Interactive comment on “Analysis of actinic flux profiles measured from an ozone sonde balloon” by P. Wang et al.

Anonymous Referee #1

Received and published: 5 January 2015

Fig. 1. Similar to Fig. 7d in the manuscript. Both single layer (red) and two layers (green) cloud simulations are shown.

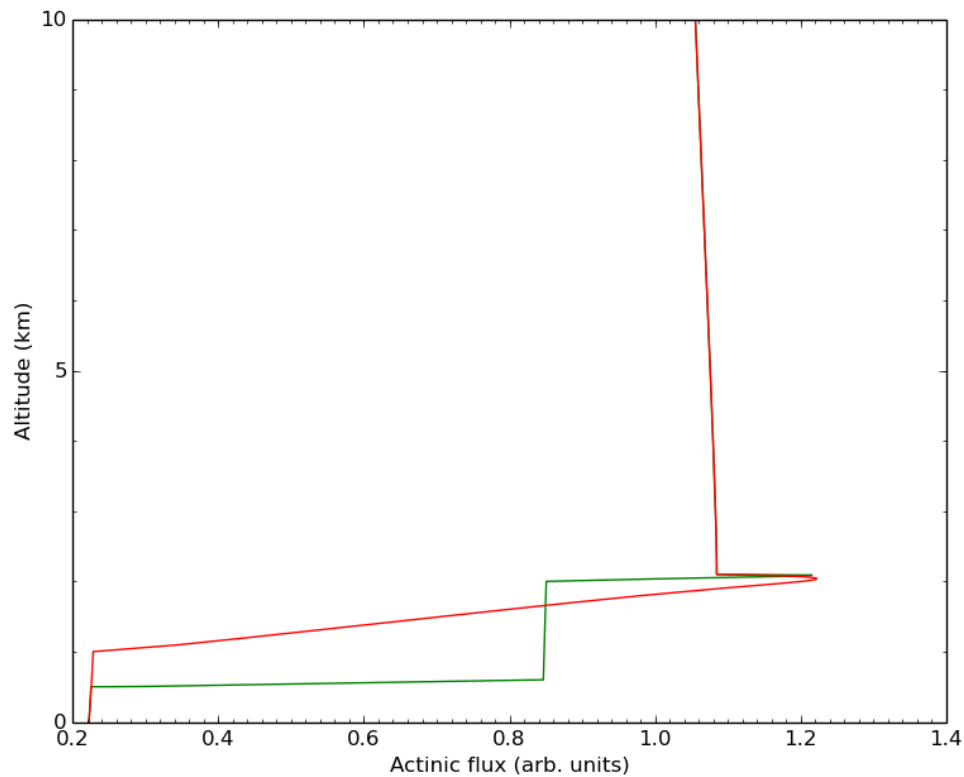
- **Page 31183, line 17:** It is straightforward with a radiative transfer model to include several cloud layers and this should be done to better reproduce the measurements. In Fig. 1 (this review) single cloud layer (red) and two cloud layers (green) simulations are included. The total optical depth was 25 in both cases and the solar zenith angle as in Fig. 7d. The wavelength is 550 nm, the surface albedo 0.15 and no aerosols were included. Clearly the two layers simulation better resembles the measurements in Fig. 7d.

The really intriguing feature with the measurements shown in Fig. 7d is the decrease in radiation as the altitude increase from about 0.5 to 2.0 km, that is between the two cloud layers. Below a sufficiently thick cloud little or no vertical variation is expected as shown by the model results in Fig. 1 (this review), green line. The behaviour of the measurements in this altitude range is unexpected. Aerosols may play a role, but it is not at all clear to this referee what the reason is for this behaviour.

Fig. 2. Similar to Fig. 11d in the manuscript. Note how the normalised actinic flux profiles change with wavelength below 15 km.

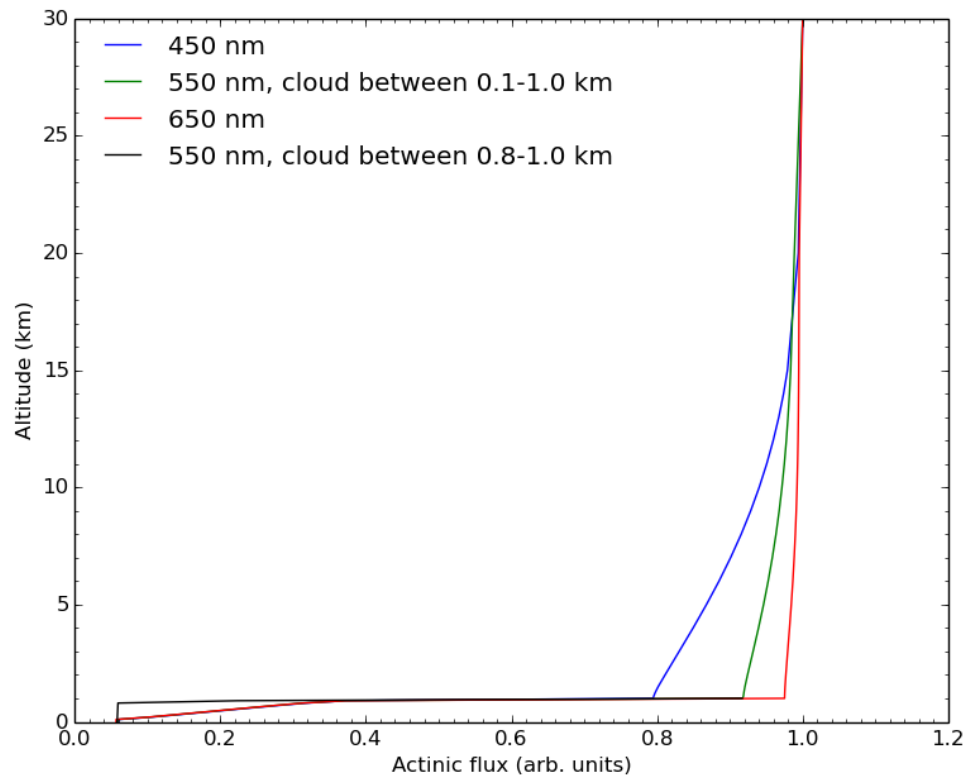
- **Page 31185, line 5:** What is meant by “properly simulated”?
- **Page 31185, lines 6-23:** For large solar zenith angles a difference between the measured and simulated actinic flux is seen below about 10 km in Fig. 11d. It is speculated that full spherical geometry is needed to explain this discrepancy. However, the DAK simulations are made for the single wavelength of 550 nm under the assumption that this single wavelength best describes the broad band response of the diode. This assumption may hold for small solar zenith angles, but not necessarily for large solar zenith angles. The clear-sky actinic flux varies with wavelength (Rayleigh scattering). To investigate this effect the actinic flux was calculated as a function of altitude for wavelengths of 450, 550 and 650 nm for a solar zenith angle of 75°. A water cloud with optical thickness of 30 evenly distributed between 0.1 and 1.0 km, was included in the simulations. Pseudo-spherical geometry was assumed. In Fig. 2 (this review) the actinic flux normalised to its value at 30 km is shown for the three wavelengths. It is seen that the actinic flux varies considerably with wavelength below about 15 km and that a wavelength of 650 nm reasonably well resembles the measurement presented in Fig. 11d. Thus the choice of 550 nm in the DAK simulations is not representative for large solar zenith angles. This example very clearly demonstrates the danger involved when using a single wavelength to simulate an instrument with a broad spectral response. Rather than using a single wavelength, the DAK simulations should be made for all wavelengths covered by the diode and the resulting spectrum convolved with the spectral response of the diode.

Finally note the difference between the black and green lines in Fig. 2 (this review). For the green (black) line the cloud optical depth was evenly distributed between 0.1 (0.8) and 1.0 km. The black line best reproduces the red line in Fig. 11d of the manuscript, but it is not clear from the text how the vertical distribution of the optical depth was for the calculation presented in the manuscript.

- **Page 31187, line 5:** After the simulations have been redone accounting for the spectral response of the diode instrument, the shapes of measured and simulated actinic fluxes will most likely agree for $SZA > 75^\circ$ and the conclusions may be changed accordingly.
- **Page 31194, Fig. 4a-b:** Have you tried to use log-scale on both the x- and y-axes in Fig. 4a? And have you tried to use log-scale on the x-axis of Fig. 4b?
- **Page 31195, Fig. 5a-b:** Please mark the launch site in Fig. 5a or even better include a square marking the region shown in Fig. 5b. Fig. 5a looks like a MODIS image obtained directly from the MODIS web site. A little more work is warranted to make the presentation clearer.
- **Page 31195, Fig. 5c:** It is not marked which lines correspond to the measurement and the model. Also, it would be interesting to include a model/measurement ratio or difference plot.
